**FEDERAL FACILITY AGREEMENT AND CONSENT ORDER (FFACO)
RECORD OF TECHNICAL CHANGE (ROTC)**

CAU Description: Frenchman Flat

ROTC No.	<u>DOE/NV--1538-Rev. 1-ROTC 3</u>	Page	<u>1</u>	of	<u>10</u>
Document Type	<u>Closure Report (CR)</u>	Date	<u>02/07/2019</u>

Technical Change No. DOE/NV--1538-Rev. 1 ROTC-2

Figure C-2
Well ER-5-3 Construction Diagram

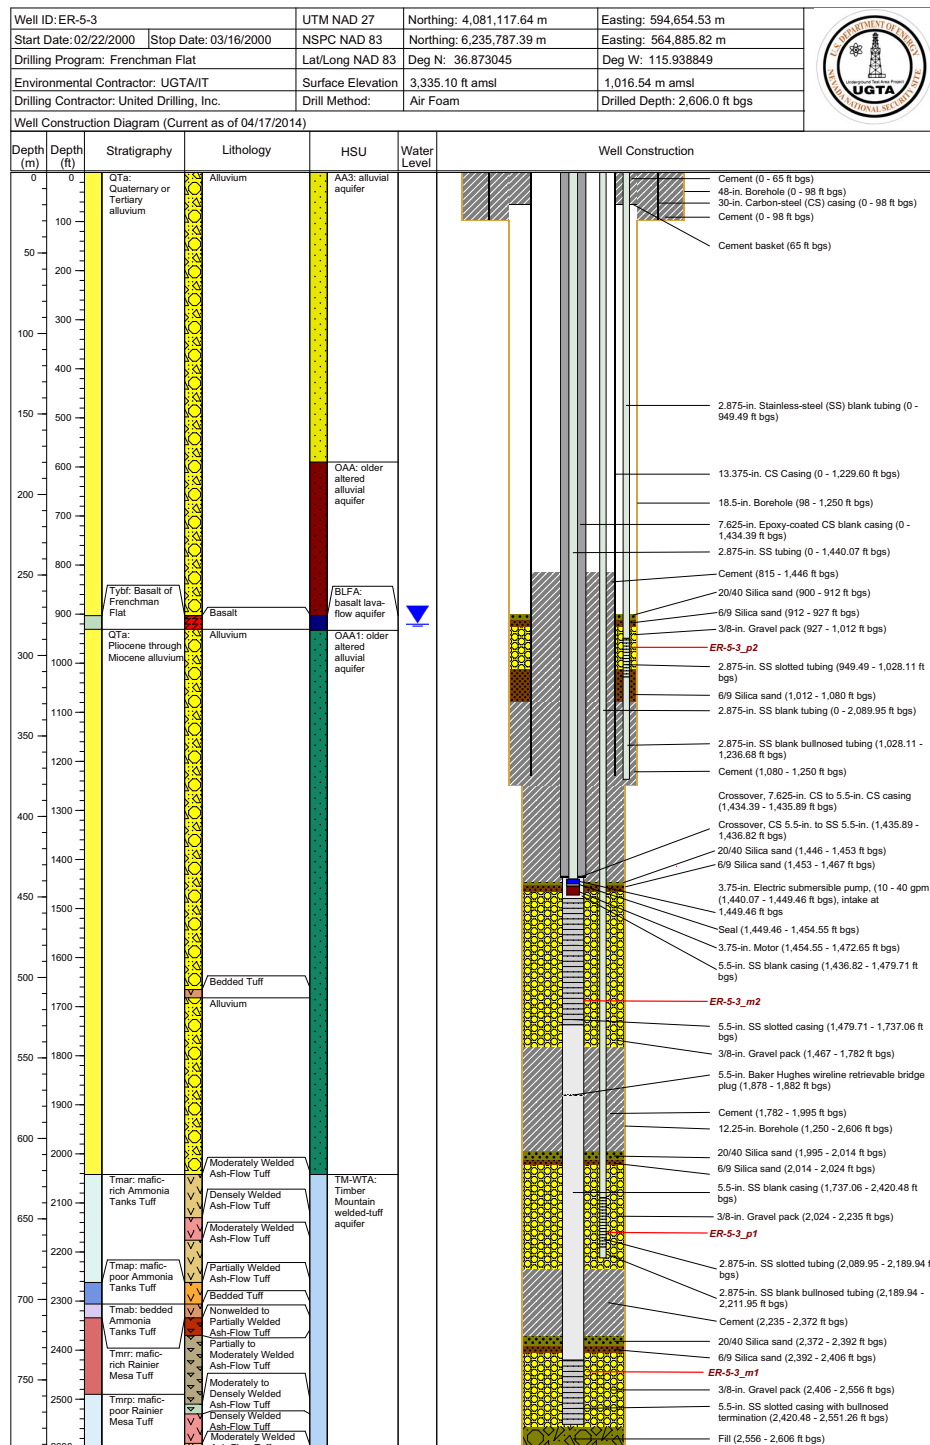
3. Table 4-2 (Page 26); and DOE/NV--1538-Rev. 1 ROTC-2
Remove last row containing Inactive Well Category.
Remove: Table 4-2
Replace with Table 4-2 (attached)
4. Section 4.1.1.1 Paragraph 2 (Page 29)
Remove: Because previous UGTA Activity sampling was limited to the main completion, the shallow piezometer has not yet been sampled. Because this piezometer has not yet been sampled, it is categorized as a characterization well.

Replace with: Well ER-5-3_p2 was sampled in 2016, 2017 and 2018 for the analyte suite required for characterization samples collected using a bailer (alkalinity, anions, total metals, and tritium). A baseline has been established. No radionuclides from underground nuclear testing were detected. This well is currently classified as an Early Detection well.
5. Section 4.1.1.2 Paragraph 2 (Page 30)
Remove: *The Nevada National Security Site Integrated Groundwater Sampling Plan, Nevada National Security Site, Nevada* (NNSA/NFO, 2014) will be used as a guidance document for identifying well types and the associated analytes, but any inconsistencies between the two documents will be resolved in favor of the CR.

3. Inactive Well category is no longer applicable.
4. ER-5-3_p2 has now been sampled three times and the location category was changed from a Characterization well to an Early Detection well as described in Justification 1 above.
5. *The revised Nevada National Security Site Integrated Groundwater Sampling Plan, Nevada National Security Site* no longer provides guidance for sampling in Frenchman Flat CAU 98 as described in Justification 1 above.
